Report of the Chief Planning Officer

CITY PLANS PANEL

Subject: Pre-application enquiry PREAPP/16/00661 Reserved matters detail for a residential development of 271 dwellings on the northern development plots at Thorpe Park, on land south of the railway line.

Applicant: Redrow Homes, Yorkshire

Development	Thorpe Park		
Location	LEEDS		
Marketing Name			
Drawing Title	Sketch Layout		
Drawing Number	TPL:16:02:SK07		
Reason	Scale @ A1	1:1000	
Drawn By	RHY	Date Issued	20.09.16
Checked by

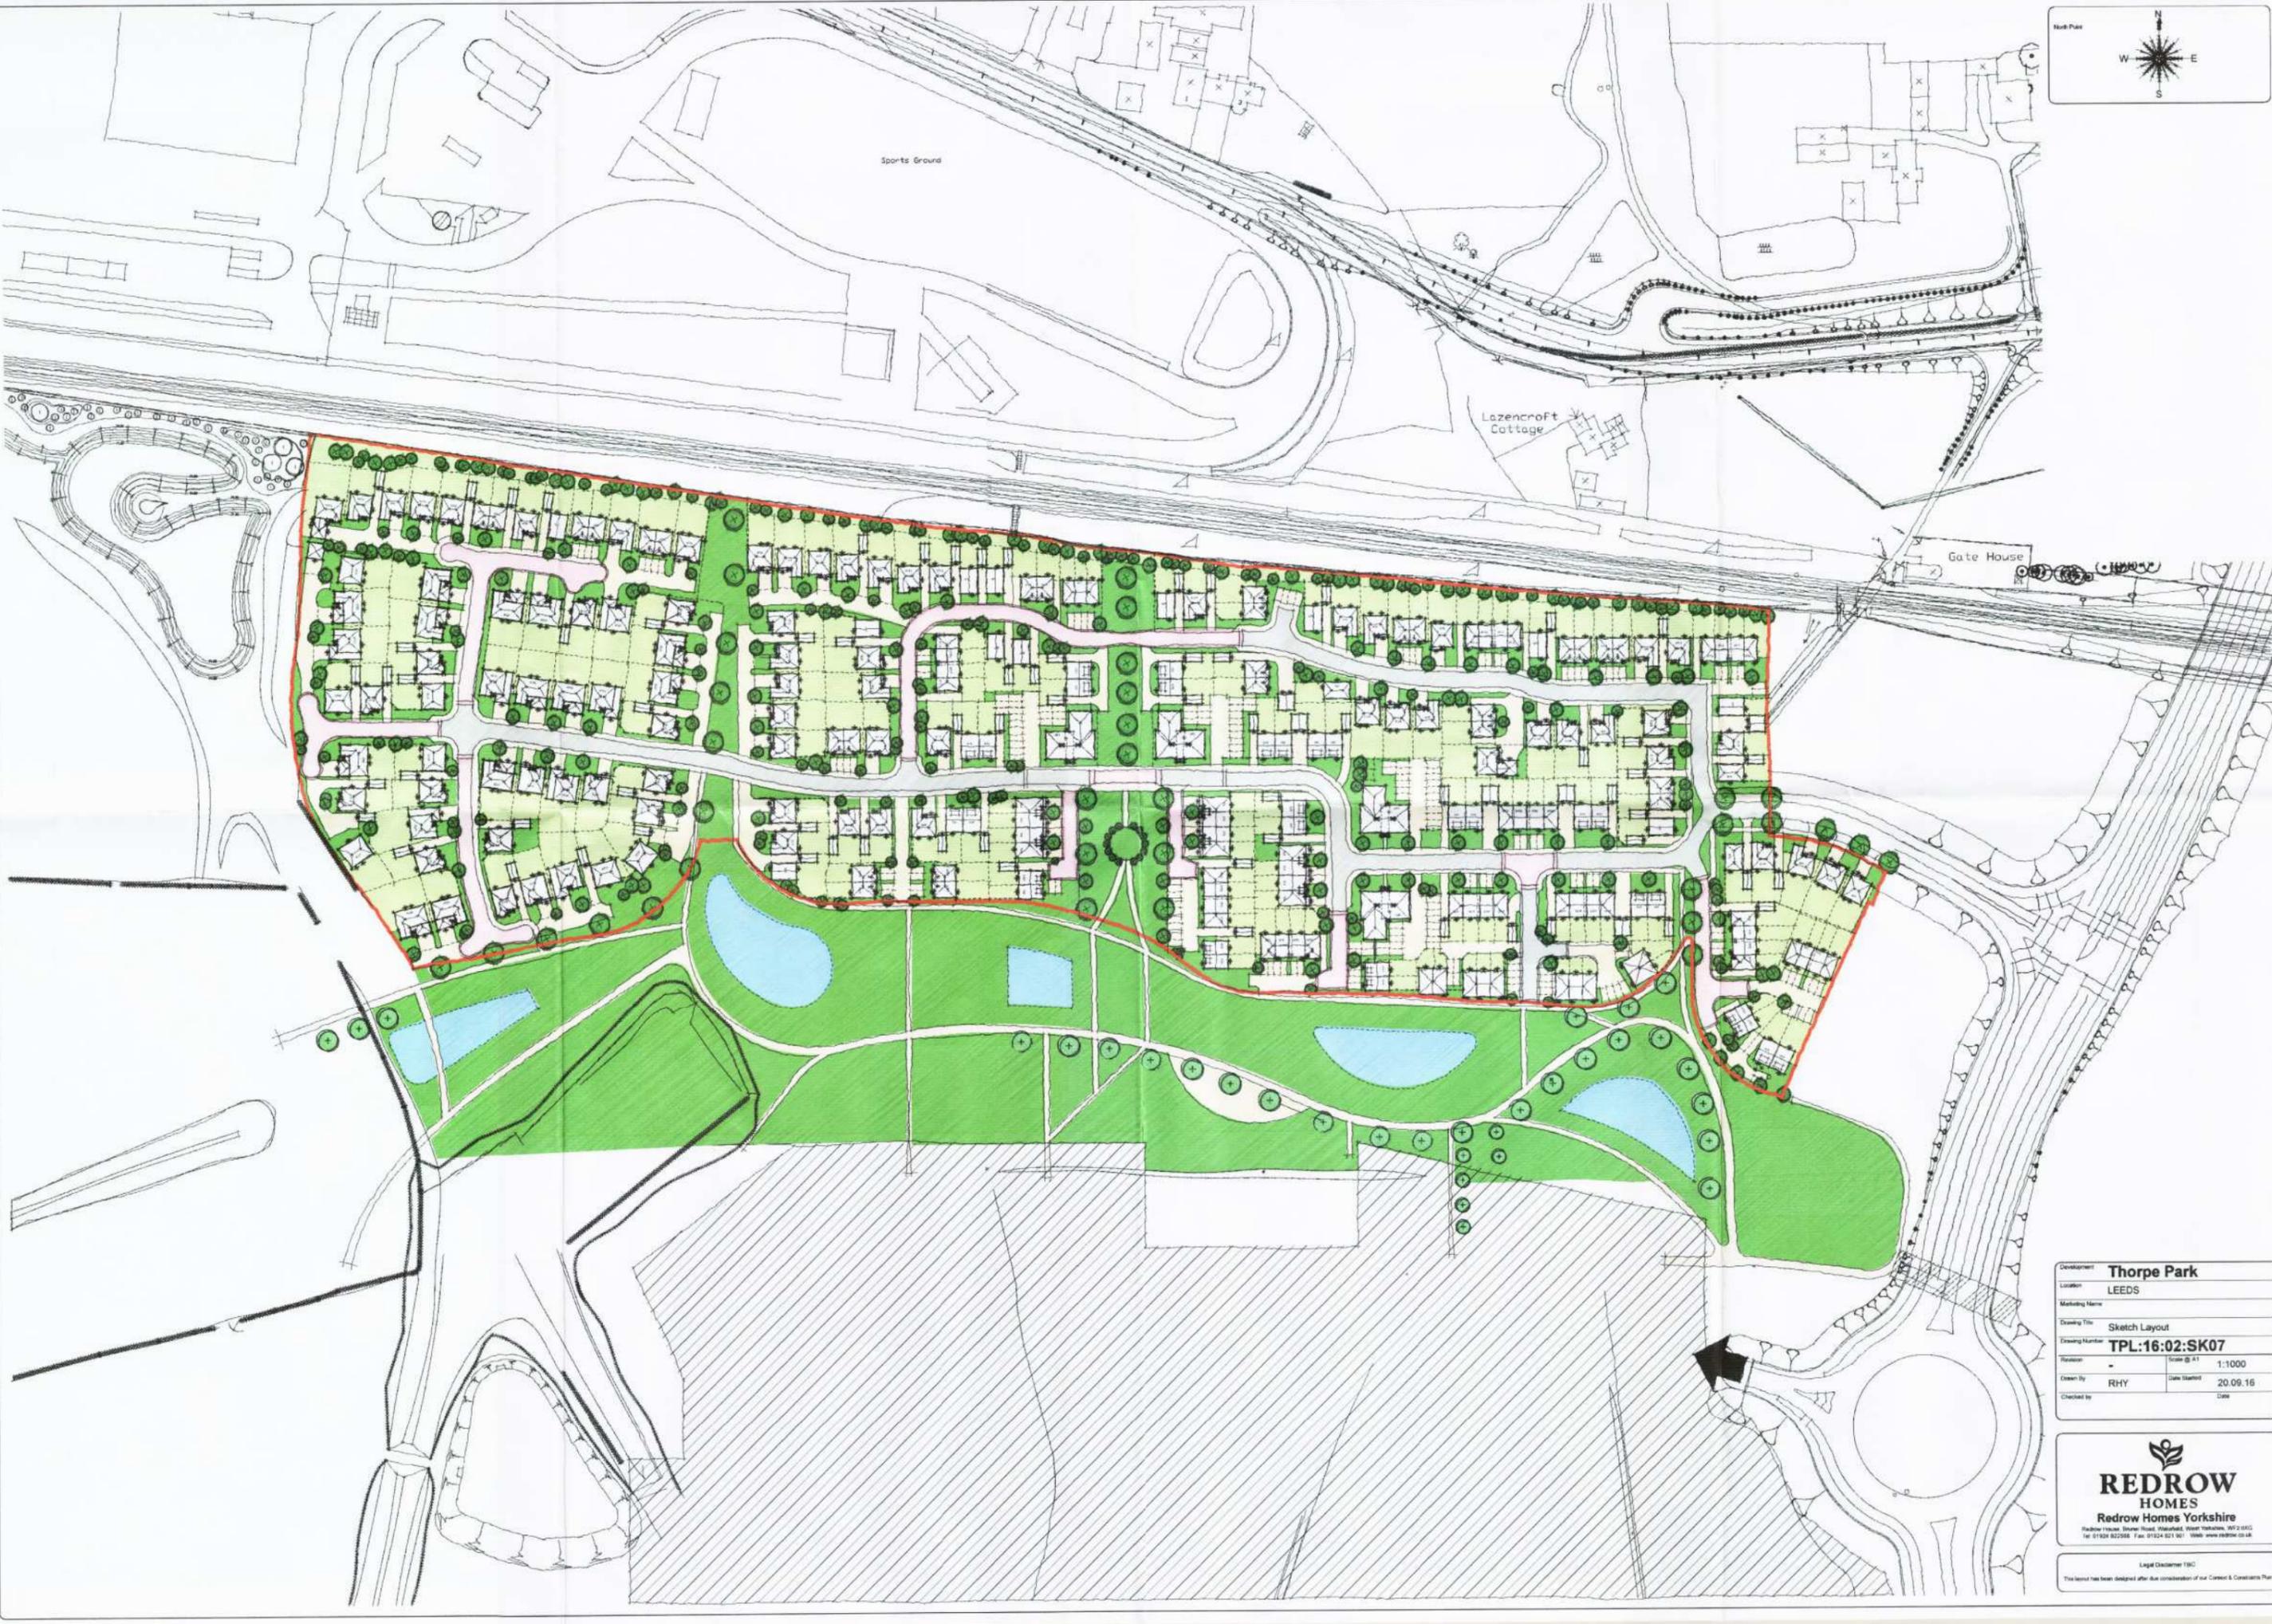
- 6.6 The currently submitted layout follows the basic parameters as set out in these approved documents, however, there is a reduction in the amount of active frontage facing Central Park in the central cell particularly. The easterly 'green finger' also appears weaker than perhaps originally anticipated with front garden areas being relied on more heavily.

- 6.7 The internal access road to the north which was originally shown to front the railway line has been moved south so that rear gardens now face the railway and houses face both sides of the road. No objection is raised to this change in principle although it will only be acceptable provided suitable sound insulation measures are incorporated to address noise associated with the train line. The approved layout provided for a landscape buffer between the built development and the railway corridor and the submitted layout still retains a buffer beyond the rear gardens.

- 6.8 **Do Members have any comments/concerns regarding the layout of the development as now advanced?**
